Re: Traffic layout certification, 5231 San Mateo NE

FACADE RENOVATION & PATIO ADDITION 5231 SAN MATEO BLVD NE ALBUQUERQUE NM, 87109

TRAFFIC CIRCULATION LAYOUT

TRAFFIC CIRCULATION LAYOUT

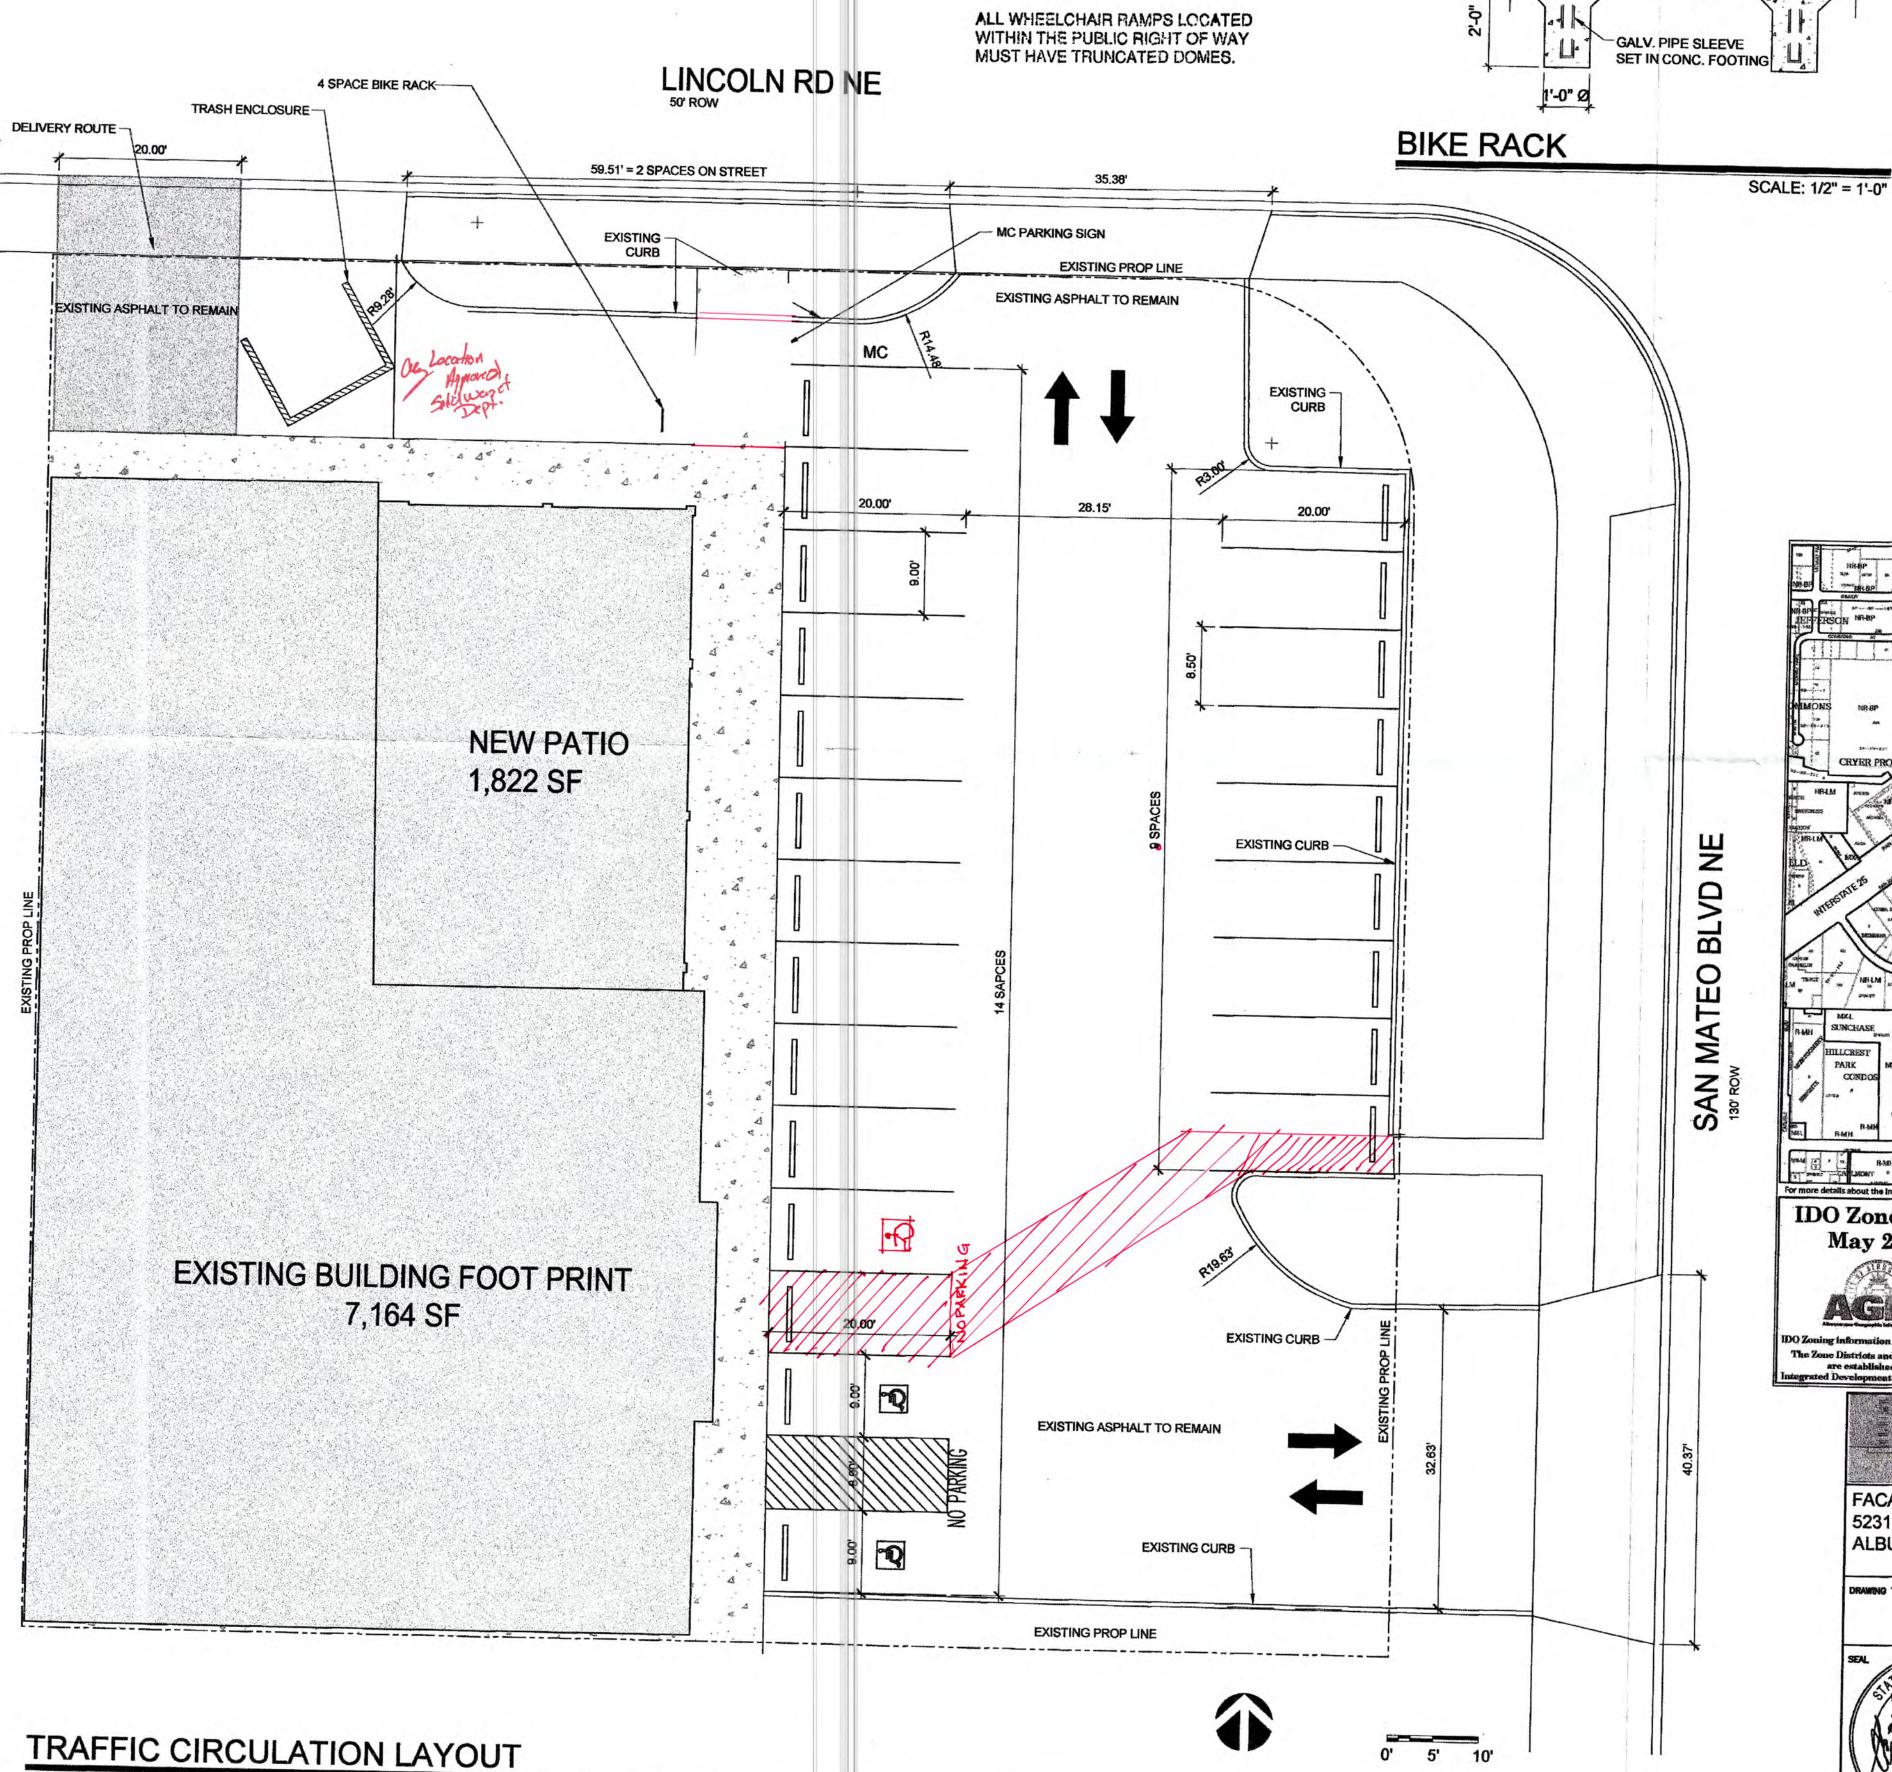
The deviations from the approved TCL dated 6/12/18 are as follows: Relocate HC parking to the north to be centered on the entrance doors. The path of egress changed from Lincoln Ave to San Mateo Blvd. Add striping to indicate the path of egress. Additional sidewalk to connect front entry to path of egress.
